HISTORIC PRESERVATION REVIEW BOARD STAFF REPORT AND RECOMMENDATION

Landmark/District: Address: Meeting Date: Case Number:	U Street 1307 S Street NW September 28 th , 2017 17-507	(X) Agenda() Consent(X) Alteration() New Construction
Staff Reviewer:	Imania Price	() Concept

On behalf of owner Christopher Cassimus, Michael P. Rouse AIA seeks conceptual review for construction of a two-story rear addition and a third story addition atop this contributing building within the U Street Historic District.

View of side elevation and roof of 1307 S Street through neighboring side yard.

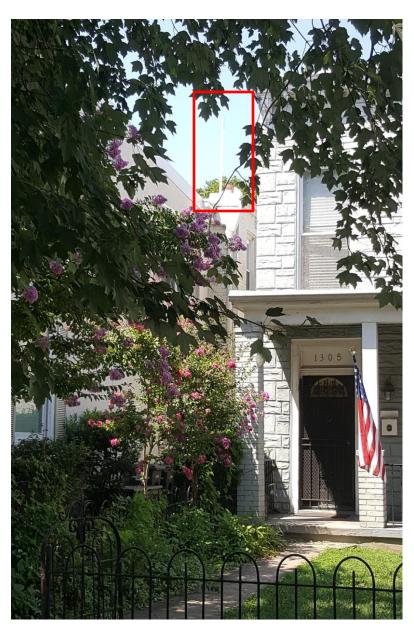
As currently proposed, the third story addition would be visible from S Street through the open side yard, which is inconsistent with the principle applied by the Board that roof additions on rowhouses should not be visible from street view. The Board's guideline for roof additions states: "Under most circumstances, roof additions that are visible from a public street are not appropriate, as they would alter an historic building's height, mass, design composition, cornice line, roof, and its relationship to surrounding buildings and streetscape – all of which are important character-defining features that are protected for historic property."

semi-detached house, HPO recommends that any third story be set back sufficiently from the front and side to ensure that it is not visible.
